## **Objection to amended designs for 6/2022/2714/HOUSE**

This objection relates to the amended designs submitted on 26<sup>th</sup> January 2023.

Plan highlighting the rear (east) side of the new office. In reality there is a rectangular inset in the wall in the northeast (rear left) corner. All the brick walls in the photograph are boundary walls.

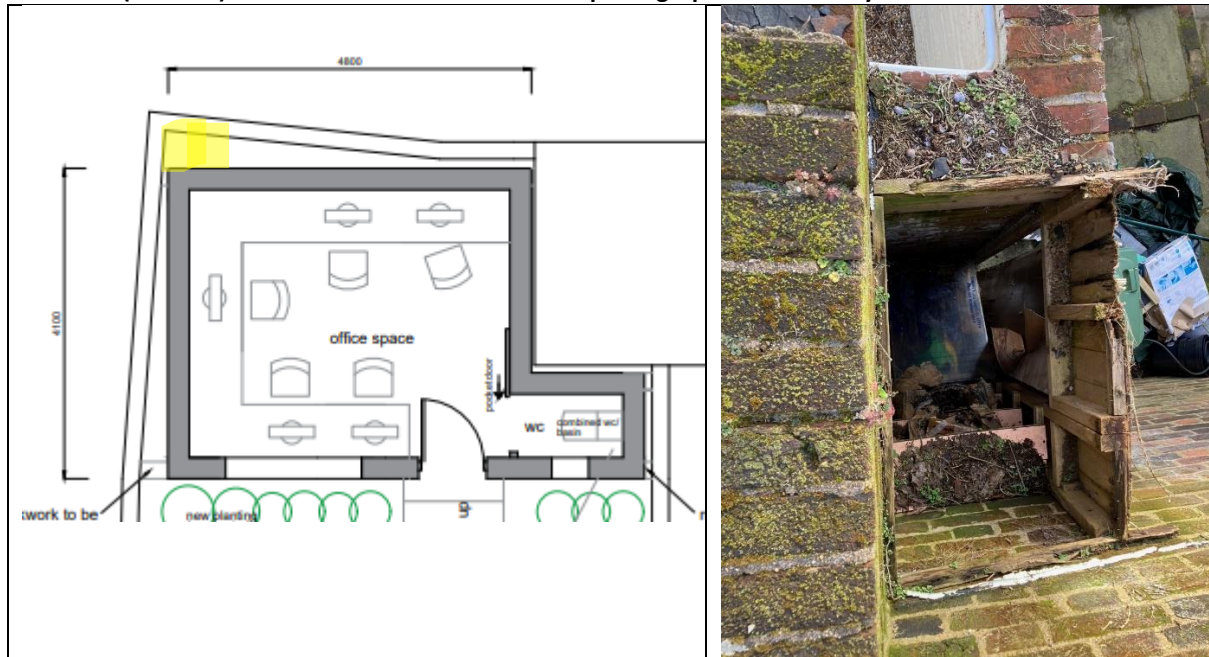
The applicants have recognised this issue and have revised their plans to seal the roof to some of the walls with a non-standard gutter system using lead box guttering. However, the revised plans do not show any gutter at the rear (east) side of the new structure. The applicants have stated they intend to seal this remaining void, but we doubt this can be achieved in a satisfactory manner.

The solution at the rear (east) side of the new office is particularly challenging because the plans submitted, including the red lined site plan, do not reflect the reality of the boundary walls. In fact there is a rectangular inset or recess in the boundary wall. (80cm wide and 50cm deep). The proposals do not give any solution for this. It is not possible to seal this with a box gutter.

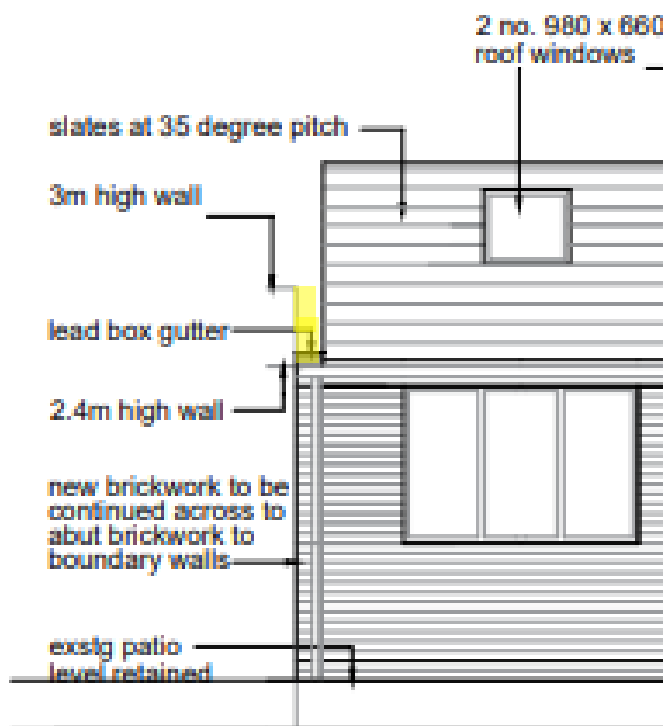
Once the building is complete, it will be impossible to repair the gutter and significant sections of the boundary walls. Normally a gutter can be accessed either from the ground via a ladder or from the roof. The setting of the office inside high boundary walls and with a steep pitch for the roof makes it impossible to do either. If the mortar/cement which attaches the lead gutter to our wall should develop any defect, this will allow water etc to enter the void. It will not be possible to repair this without removing at least the roof of the office.

We assume the construction process will be i) erect the 2.5m walls of the office ii) affix the lead gutter iii) erect the roof which rises to 4m above the existing patio or 4.4m above ground level. At the north and south sides of the new office, the roof will be some 1.5m above the gutter. It should be possible to climb onto the roof and use a suction hose to clear out the gutter. It will not be possible to repair any defect. If, during construction of the roof, anything should be dropped into the gutter or against the wall, it will not be possible to repair the damage to the gutter or brickwork (without removing the roof).

Section to illustrate how the roof rises 1.5m above the gutter. There is restricted access from the other side of the boundary wall due to the configuration of the outbuildings which are against the wall. A ladder cannot be used, and the gutter is still 0.5m below the top of the wall. If someone were to perch on the wall, they would need to repoint / repair a narrow gully 0.5m below their feet.
